Tube-Based Crossovers

January 2003, p. 60-65 (020297-1).

020297- 13

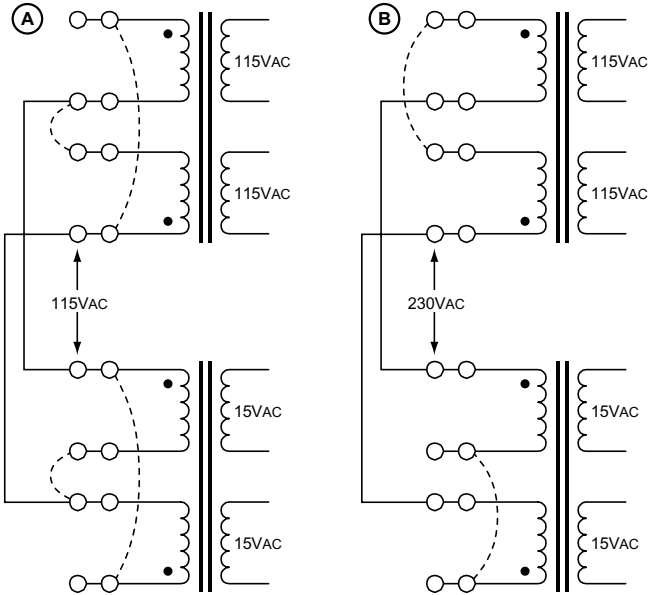
A number of errors have crept into the drawings in Figure 3 on page 61 of the article. In Figure 3a, two unnecessary and possibly harmful wire links are shown, while the labels '115 V' and '230 V' in Figures 3a and 3b should have been transposed. Also, all transformer secondaries should have been marked '115 V', not '15 V'. To prevent misunderstandings the corrected drawings are printed here.
